SOUTHERN CLOTHINGS LIMITED

(Extension)

12 June 2023

Observations

Live load table of BNBC-2006

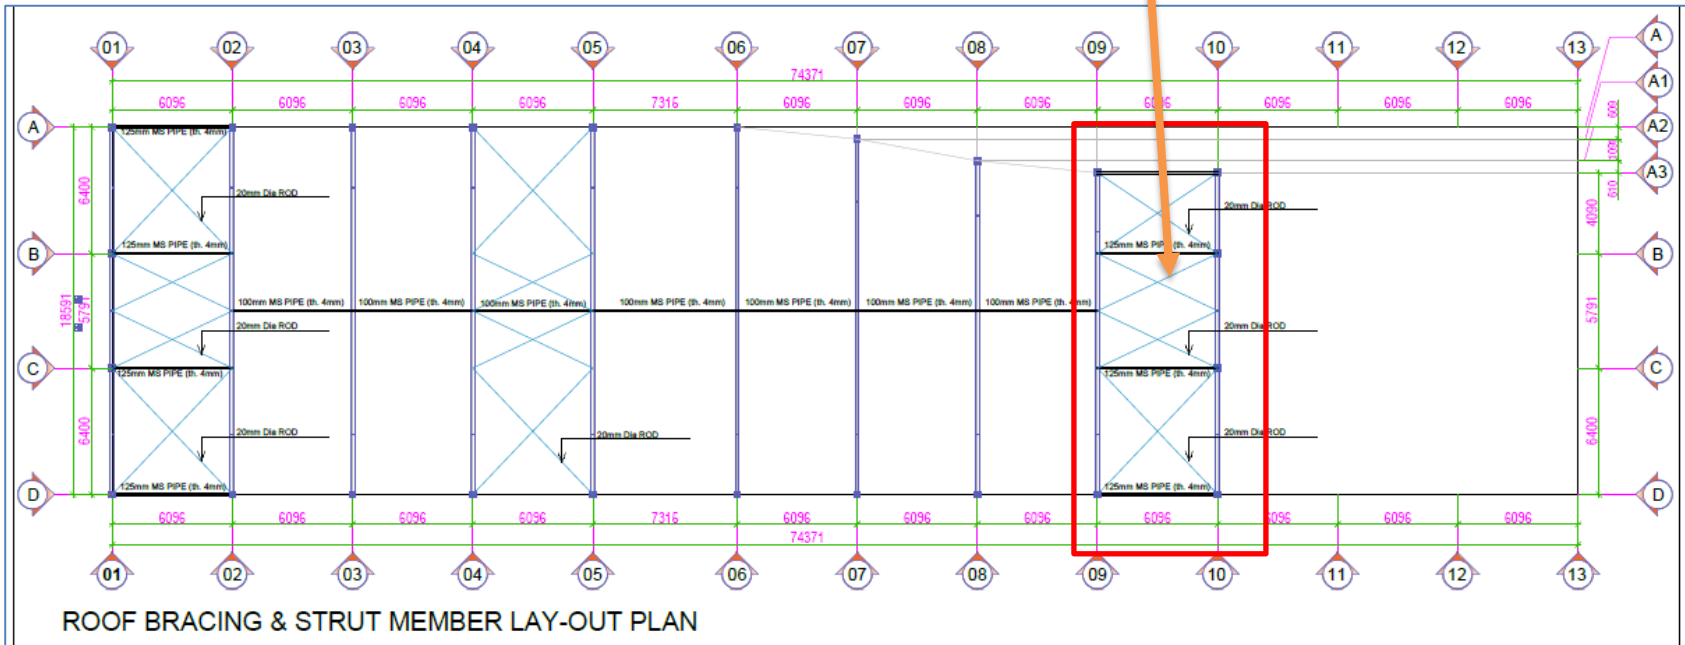
**Load plan & design report not comply
with BNBC requirements**

Currently, the typical floor of the building is being allotted for fabric store. As per BNBC, the minimum floor live load for light storage is 6 kN/m² (125 psf). But the storage (typical floors) area of the building is designed for 5 kN/m² live loads. The building engineer is required to revise the storage live load limit and related design documents based on BNBC requirement.

Significant connection gap

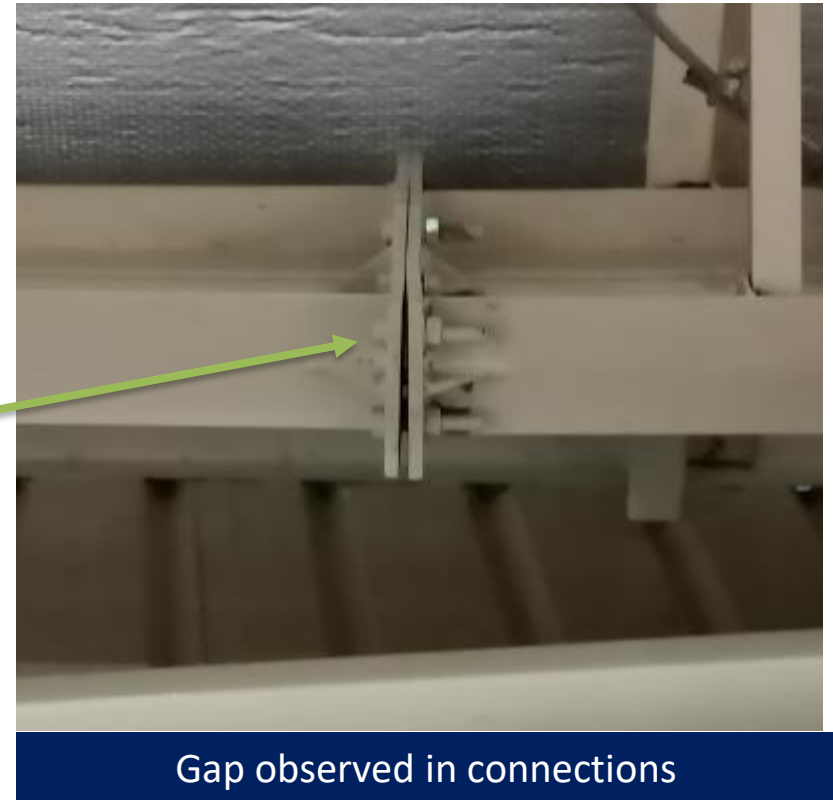
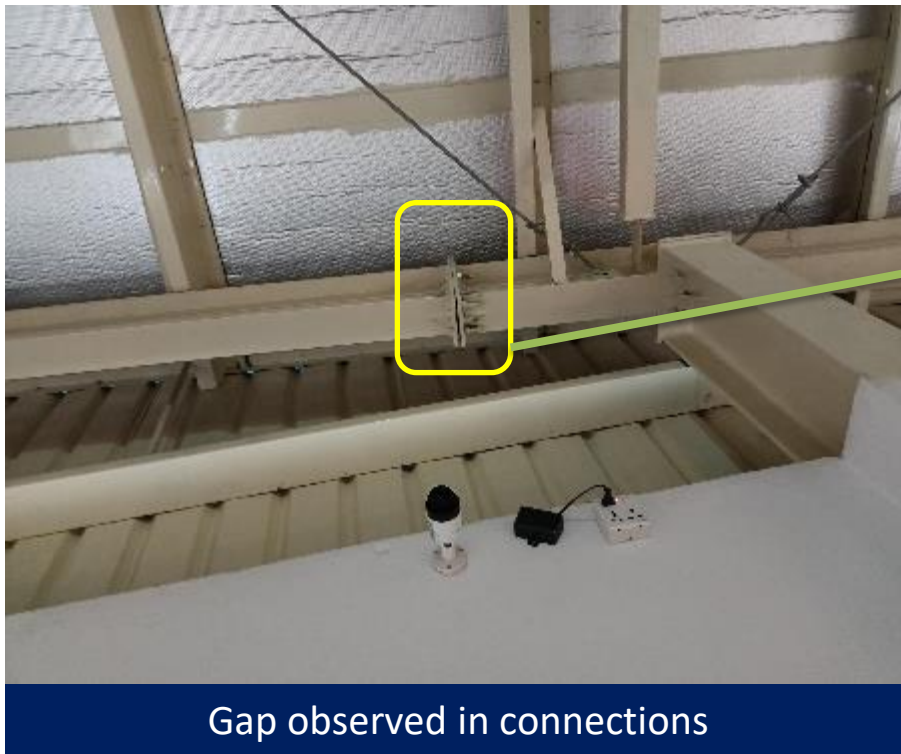
Significant gaps observed in Rafter-column joint at several locations. Building engineer is required to carry out suitable remedial works.

Material strength in the design report

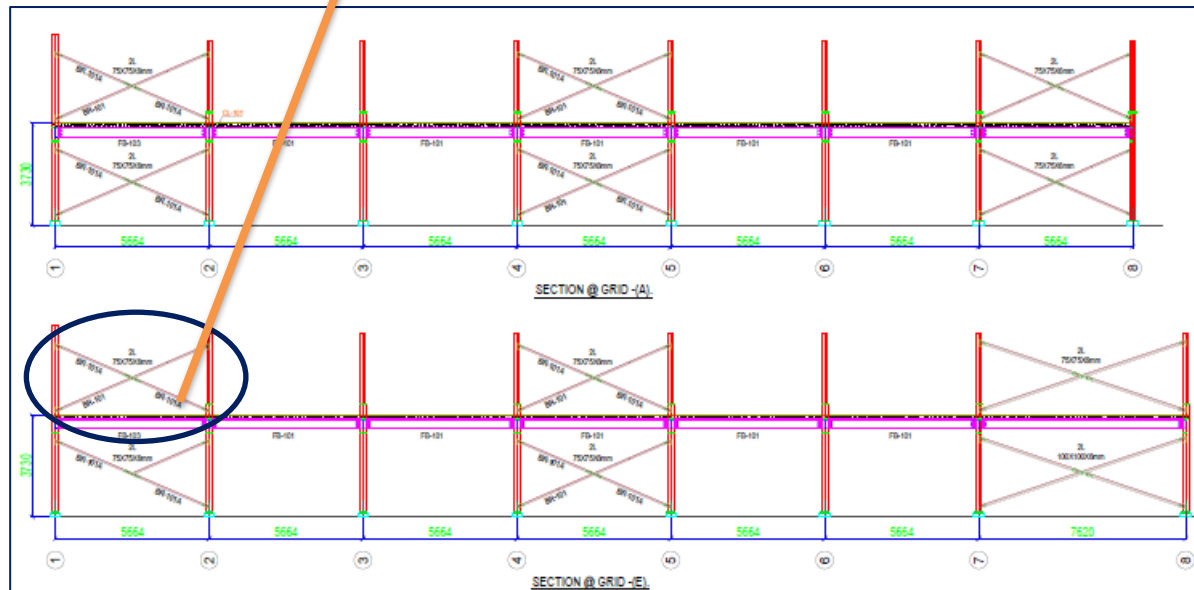
Tensile strength of MS plate was considered 345 Mpa (50 Ksi) but no plate test report was found during the inspection. Building engineer is required to confirm the tensile strength of MS plate from existing building.

Distorted steel column

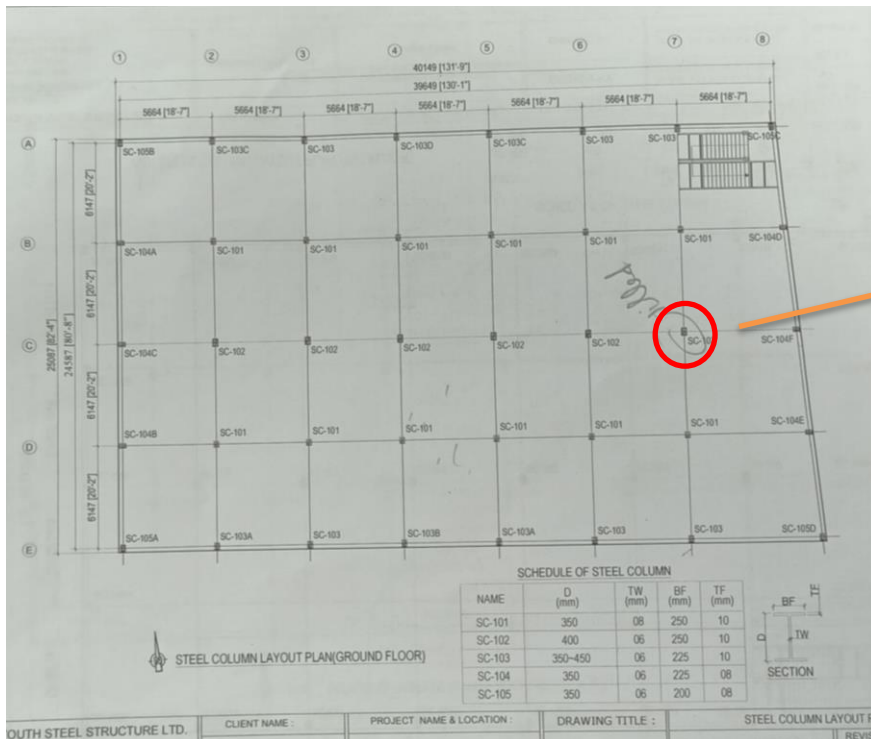
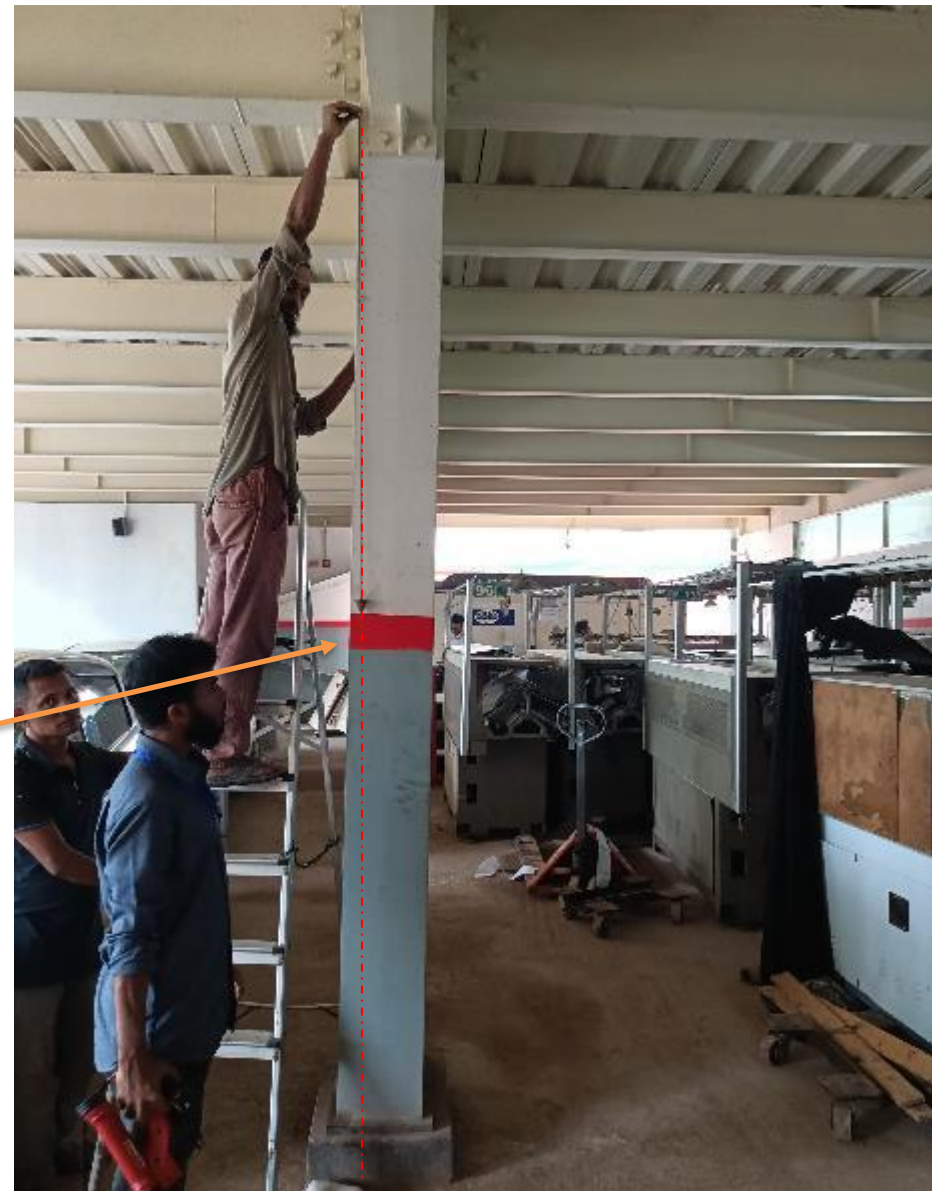
A distorted steel column found on ground floor in parking areas. Stability for the distorted columns and related elements need to be checked. Factory Engineer to review design, loads and column stress in the area identified above.

Columns susceptible to vehicle impact

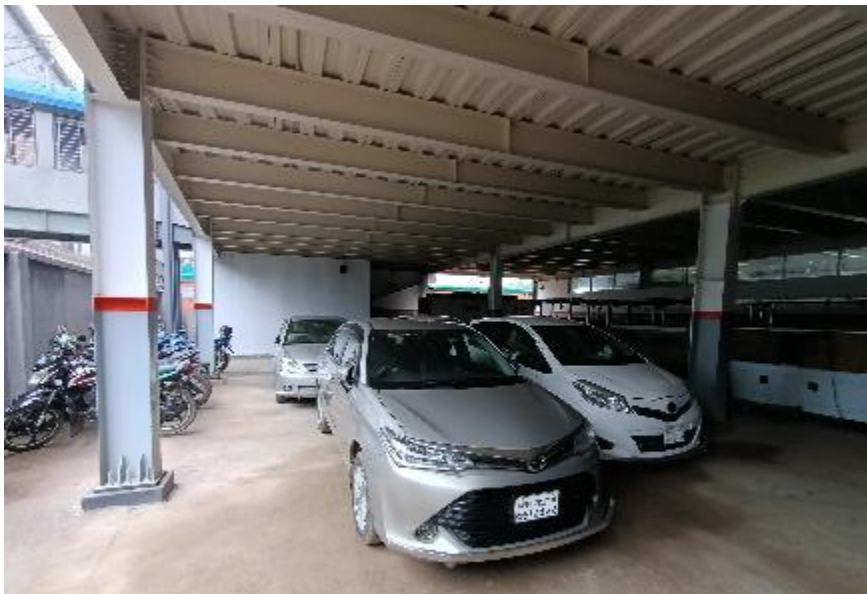
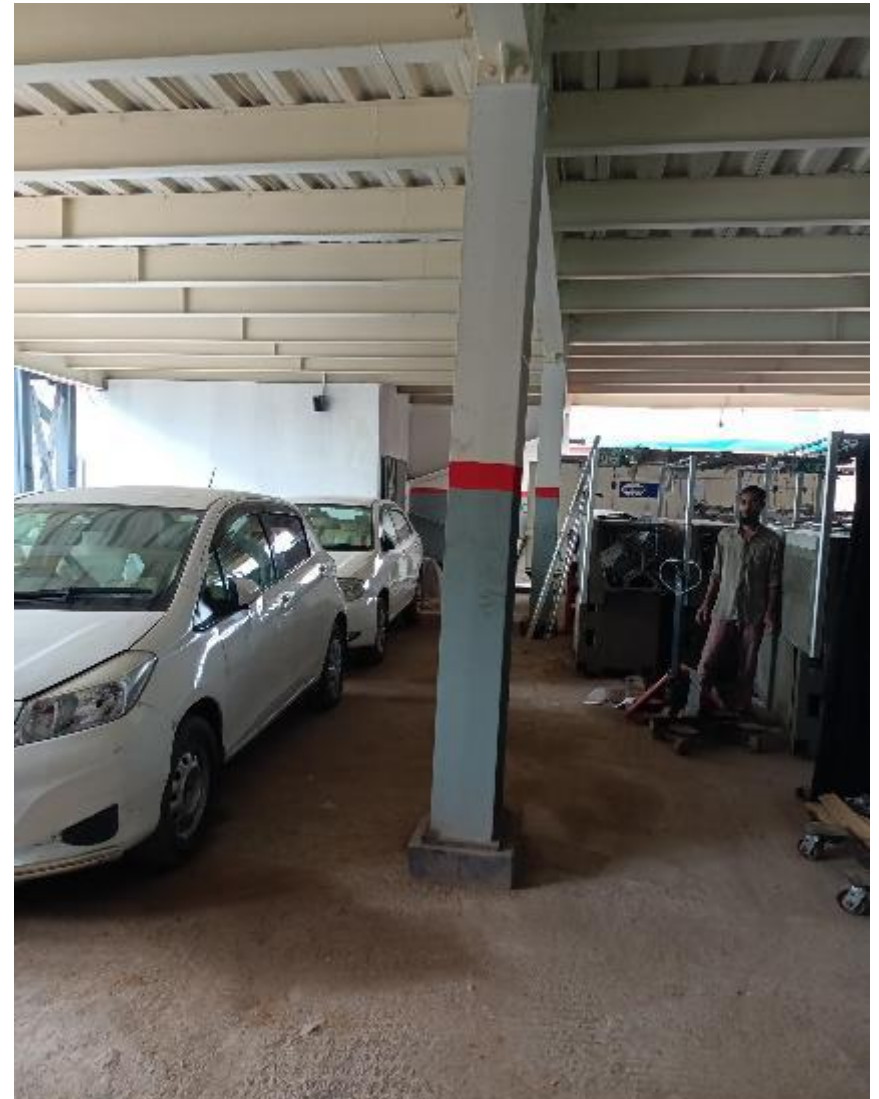
Columns are susceptible to vehicle impact in the parking areas on ground floor. Building engineer is required to install a barrier to prevent vehicle impact in column.
